Repair Notice

617-1

PX-9 engines may develop a leak from return fuel fitting

6/7/2017

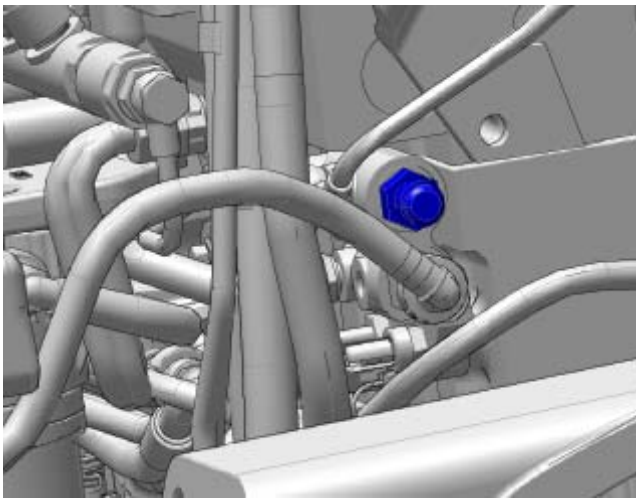
1. Remove the return line from the fitting

2. Remove the return fitting from the engine.

3. Install the new return fitting and torque it to 95 N·m (70 lb-ft).
4. Connect the return line to the fitting.
